# Report of the Director of Regeneration and Culture to the meeting of Bradford South Area Committee to be held on the 24<sup>th</sup> January 2013.

A Ward Investment Traffic Regulation Order at various locations for various waiting restrictions is being progressed in the Great Horton Ward. At one of the sites on Birks Fold adjacent to Birks Fold Primary School, 3 objection/comments have been received.

11.1 Appendix 1 – Proposed waiting restrictions on Birks Fold.

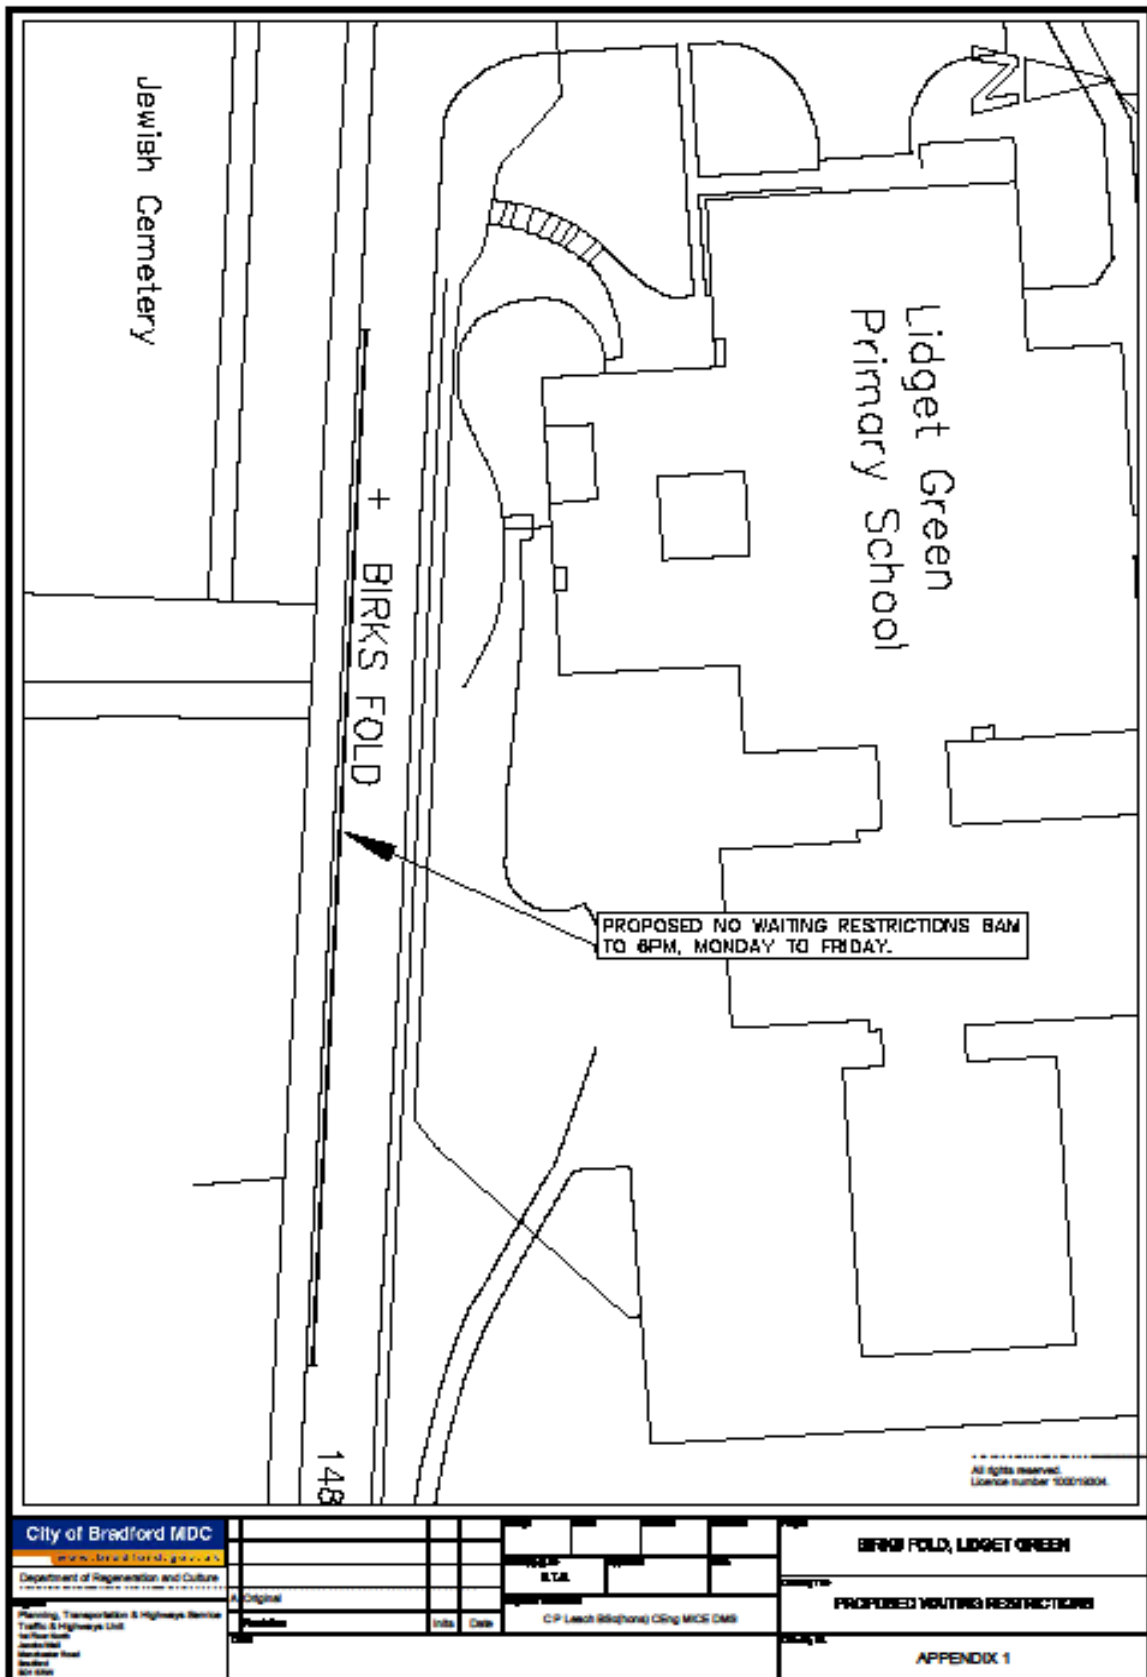
Objection/ Comment	The Objection/Comments	Officers Comments
Objection 1	<p>The children are dropped off at school from 7.45am and may not be collected up to 4.30pm, the proposed restrictions will force parents to drop off/pick up away from the school with the children having to cross the busy Cemetery Road at the Pelican Crossing especially when there is no school crossing patrol operating.</p> <p>The new Asda supermarket on Cemetery Road, the new Kings Science Academy when fully open and the proposed new housing on Northside Road will also have an impact on this school and parking requirements in this area.</p>	<p>Parking wardens do allow vehicles to stop and drop off and collect but not longer than 5 minutes, but this does not apply to school keep clear markings.</p> <p>The proposed restrictions will maintain access and egress in both directions especially at school times and maintain access for emergency services to the nearby residential properties, the school, maintain passage for the funeral currettages that are leaving Scholemoor Cemetery and other traffic.</p> <p>Additional waiting restrictions have been introduced for the Asda on Cemetery Road and nearby streets in accordance with the planning conditions.</p> <p>A new car park is being constructed at the rear of the Kings Science Academy with various measures introduced to deal with the parking issues, in accordance with the planning conditions.</p> <p>The new housing development will generate less traffic than the previous industrial developments on Northside Road.</p>

Objection 2	<p>The proposed waiting restrictions will push parked cars into the cemetery, the cemetery car park and Robinsons Court which is part adopted/private.</p> <p>The school already dominates on-street parking during term time</p>	<p>This can be resolved with the introduction of additional measures – a permit parking zone and permit parking places for those properties fronting the remaining lengths of Birks Fold and Robinsons Court with waiting restrictions to protect drive ways and maintain access.</p>

<p>The Cemetery Management have offered the use of their car park off Birks Fold to the school and to parents, but this offer has not taken up.</p> <p>Additional signing can be introduced which encourages the usage of the car park</p>
<p>Comment 1 from the Department of Children's Services</p>	<p>Recent consultations with parents, has shown that many are concerned about the dangers to their children from cars using Birks Fold.</p> <p>The impact of parents dropping off and collecting pupils from the school is in general focus on 2 particular time periods during the day.</p> <p>Birks Fold is relatively narrow and has in addition to the school the cemetery access which exacerbates the situation.</p>	<p>The proposed restrictions will maintain access and egress in both directions especially at school times and maintain access for emergency services to the nearby residential properties, the school, maintain passage for the funeral currettages that are leaving Scholemoor Cemetery and other traffic.</p>

- 4.1 That the proposal shown in Appendix 1 be modified to accommodate the proposals shown in Appendix 3. The proposal is to replace a section with a limited waiting restriction for a maximum of 10 minutes, no return prohibited within 1 hour to provide short term facilities for drop off/collection of children for 4 vehicles at the nearest point to the school so that adequate space is maintained so vehicles can enter Birks Fold safely, provide room for passing traffic. That signs are also erected on Birks Fold and at entry to the cemetery where the car park is located within it to encourage its use by parents who continue to take children to this school and staff.
